Letter I51m

Subject: Revised DEIR Public Comments Regarding Water, Waste Water, and Storm Water Impacts, and DEIR Chapter 2 and 3 Water, Waste Water, and Stormwater Impacts, Lilac Hills Ranch General Plan Amendment and Specific Plan PDS2012-3800-12-001(GPA), PDS2012-3810-12-001 (SP).

Subject: DEIR Public Comments Regarding Water Quality Standards and Related Requirements for the Proposed Accretive Lilac Hills Ranch General Plan Amendment and Specific Plan PDS2012-3800-12-001(GPA), PDS2012-3810-12-001 (SP).

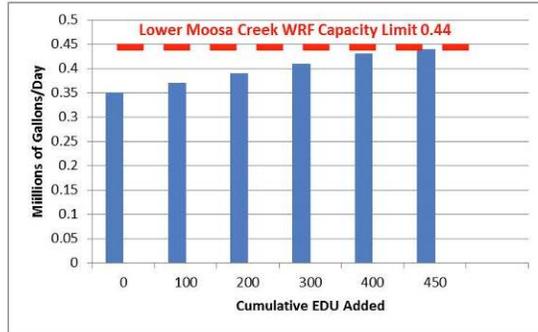
The present capacity of LMWRF allows addition of a maximum of 450 Equivalent Dwelling Units (EDU's) until secondary percolation ponds are at full permit capacity. See Graph below:

Question 6) Assuming the 0.44 MGD percolation pond limit, only 450 maximum EDU of influent can be added to LMWRF. Question: What is the current number of EDU's of outstanding applications for land development permits + EDU's from permits granted but not yet built from the existing LMWRF service area? For example Castle Creek Condos, Welk Resorts, and Champagne RV Park are current processing discretionary permits for the addition of 260 EDU within the current LMWRF service area. Please tabulate all other outstanding EDU's from pending discretionary permits and list the total. This analysis is also appropriate under the cumulative impacts section of the DEIR.

151m-8 The 1996 EIR includes a Preliminary Design Report for the LMWRF to expand to 1.0 mgd to accommodate the LMWRF service area. Expansion of the LMWRF service area will occur independent of the proposed project. Expansion above 0.44 mgd will require the addition of Title 22 tertiary treatment facilities to recycle wastewater flow greater than 0.44 mgd. Use of the LMWRF by the proposed project will be at the discretion of the VCMWD. As previously noted, should the LMWRF not have sufficient capacity, one of the other alternatives examined in FEIR subchapter 3.1.7 would be used to ensure wastewater treatment was available for the project.
